County of Fairfax, Virginia
Planning Commission Meeting
May 13, 2026
Planning Commission Action

2232-2025-SU-00010 – WESTERN HIGH SCHOOL
(Sully District)

April 22, 2026

Application Number:	**2232-2025-SU-00010**
Applicant:	Fairfax County School Board
Proposed Use:	Public High School
Supervisor District:	Sully
Subject Property Tax Map ID:	24-4 ((1)) 3C, 3D, 3E, 3F
Subject Property Address:	2949, 2950, 2954 Education Drive Herndon, VA 20171
Area of Subject Property:	32.7 acres
Application Accepted:	November 12, 2025. The Board of Supervisors extended the initial application deadline to October 6, 2026, to allow for adequate time to review and for the applicant to respond to revisions.
Recommendation:	In accordance with Va. Code Sec. 15.2-2232, as amended, staff recommends that the Planning Commission find that Phase I as outlined in the staff report and proposed by the Fairfax County School Board to convert an existing private school to a new public high school, is substantially in accord with provisions of the adopted Comprehensive Plan.

Figure 2: Western "Skyview" High School General Site Layout, Source: Applicant

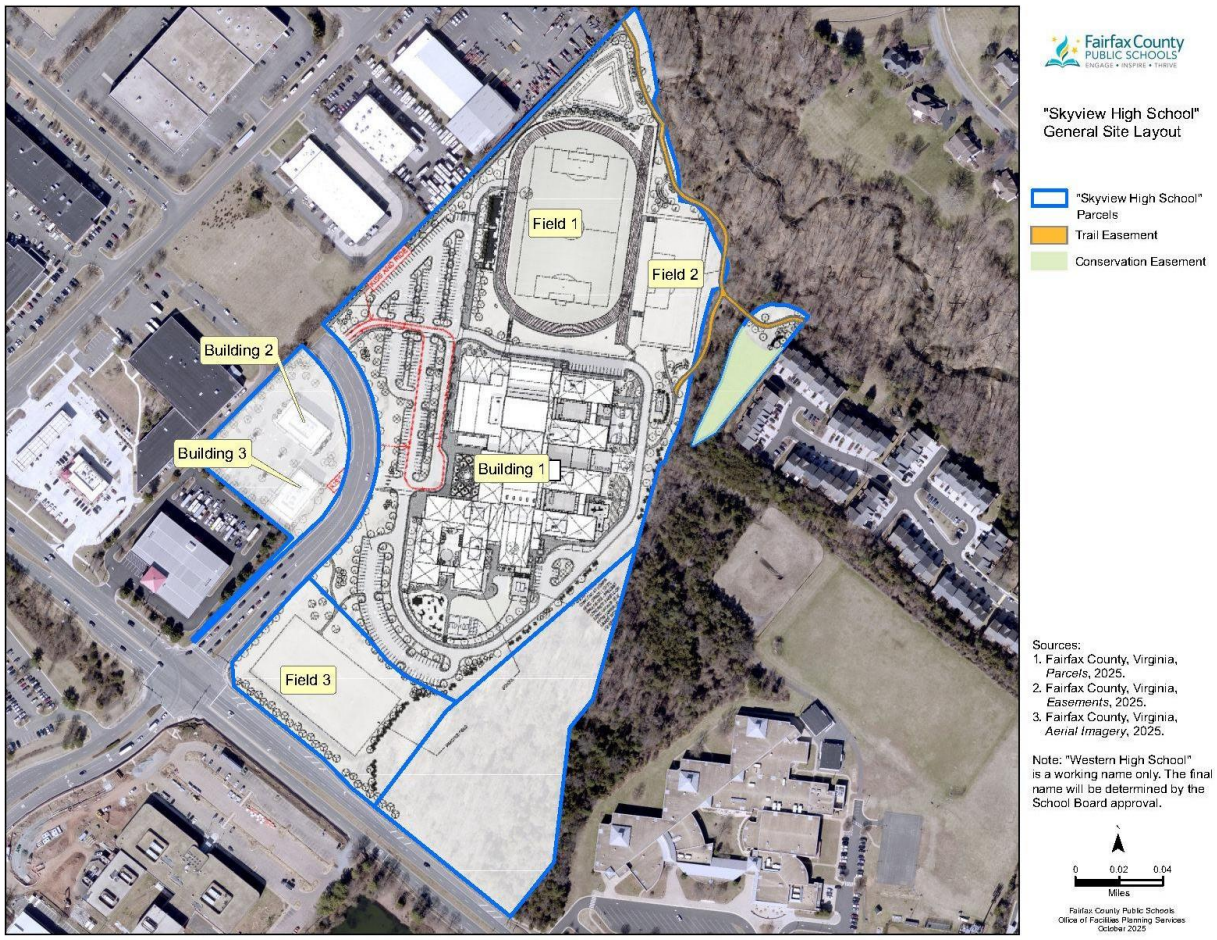
The Fairfax County Park Authority (FCPA) also notes the extent and character of the modifications to the existing athletic field, including the proposed field lighting, is not depicted or described in detail with the submitted materials. The location, extent, and character of these modifications may impact sensitive natural resources (trees, slopes, night time wildlife corridors) in FCPA's Horsepen Run Stream Valley Park (SVP). Since the location of the existing field is fixed and impact avoidance may not be practical, FCPS

- Provide more details on impacts to the existing athletic fields and recreational spaces. These spaces, like the school use, should be considered as part of the public facility approval.
